Date: June 26, 2019

To: Steve Wilson, Executive Director, Wilmette Park District

Subject: Neighborhood Storage Project—Responses to Questions

The purpose of this memorandum is to provide responses to the Park Board and resident questions that arose at and following the June 10 meeting. Village staff and the consulting team will be available on July 8 for the next Park Board meeting to answer any additional questions.

**HIBBARD PARK – UNDERGROUND DETENTION CONFIGURATION ALTERNATIVES
VILLAGE OF WILMETTE, ILLINOIS**

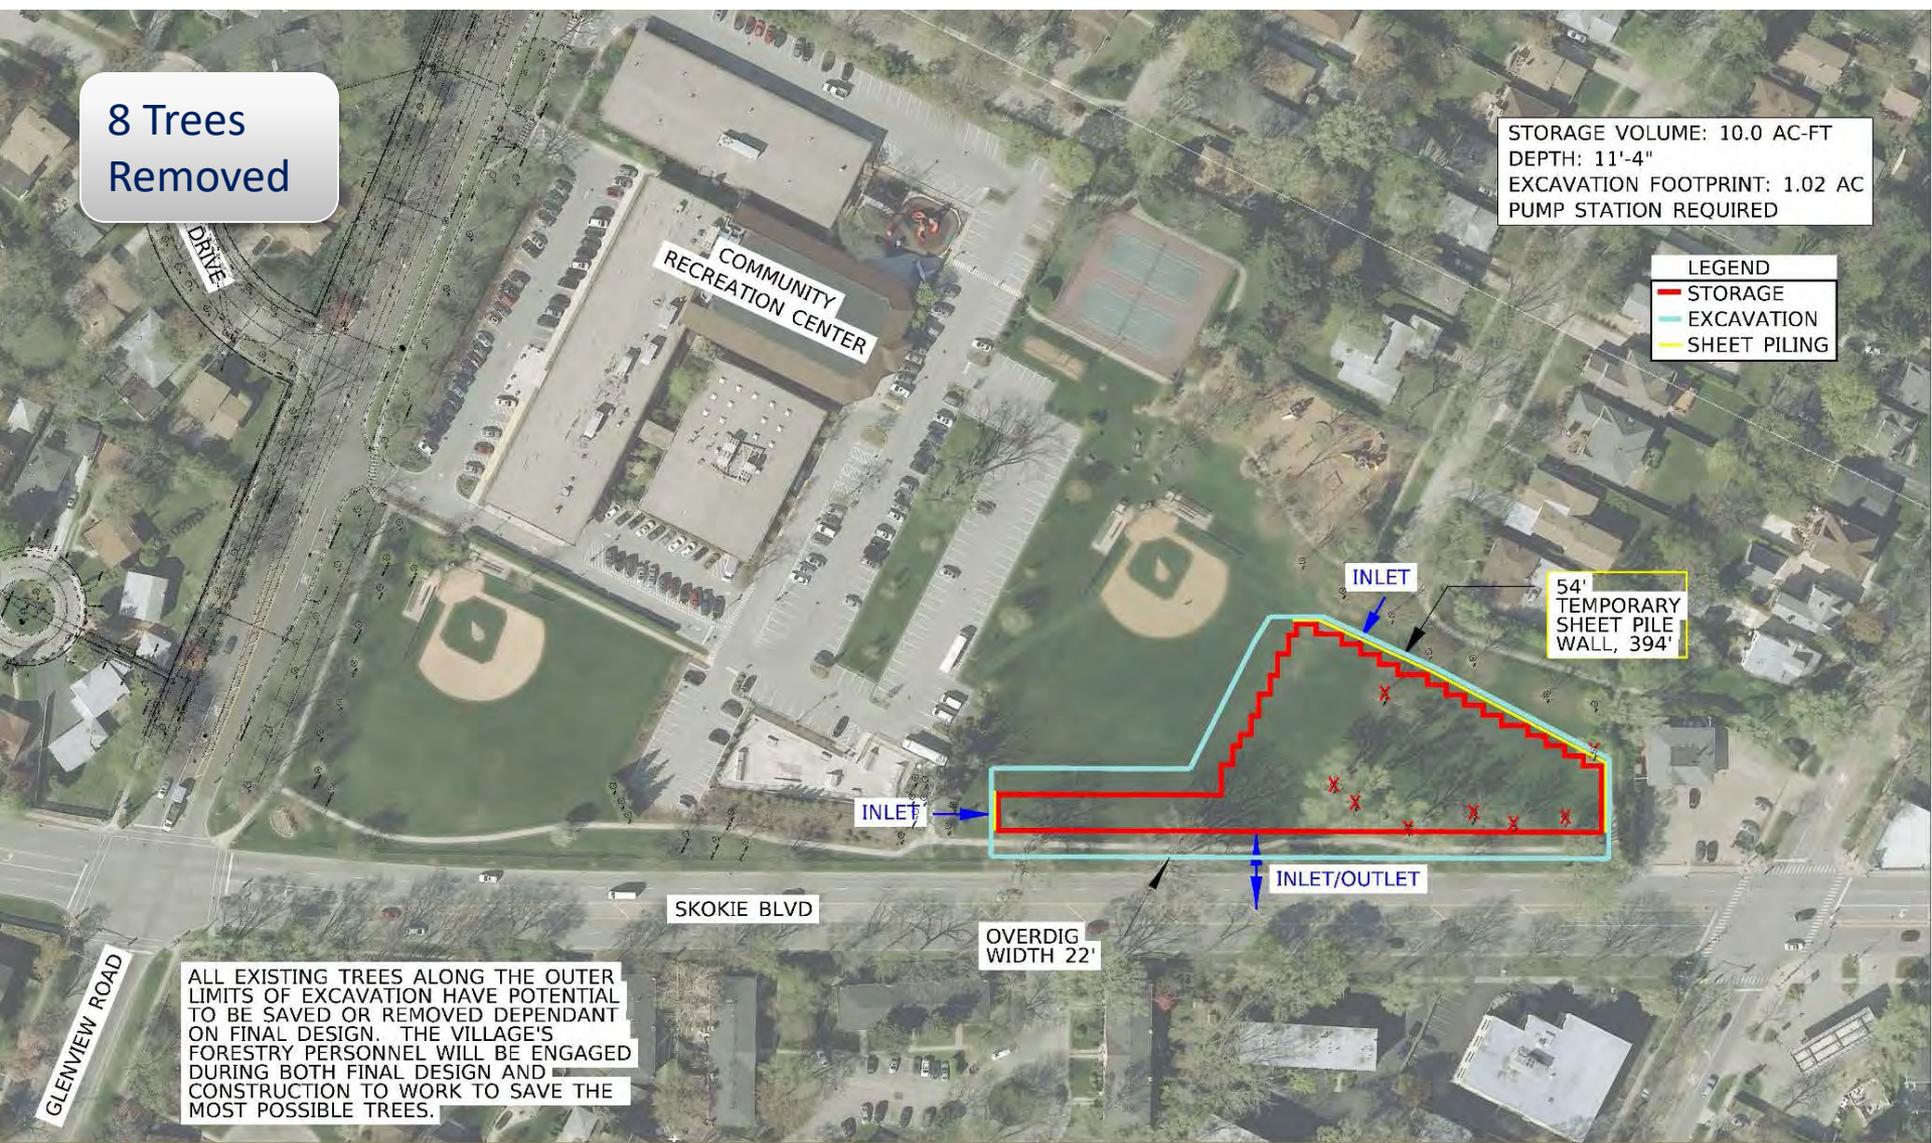
9. Is there a solution that has a pumped tank under the southern baseball field at Hibbard Park and what the tree impact would be.

There are options to utilize more of the southern baseball field for underground stormwater storage. This area was not originally considered as it impedes into the area identified by the Park District’s architect as potential area for future building expansion. The attached conceptual exhibit shows how a pumped (15’ deep) detention vault could fit under the south baseball field. (Attachment 3)
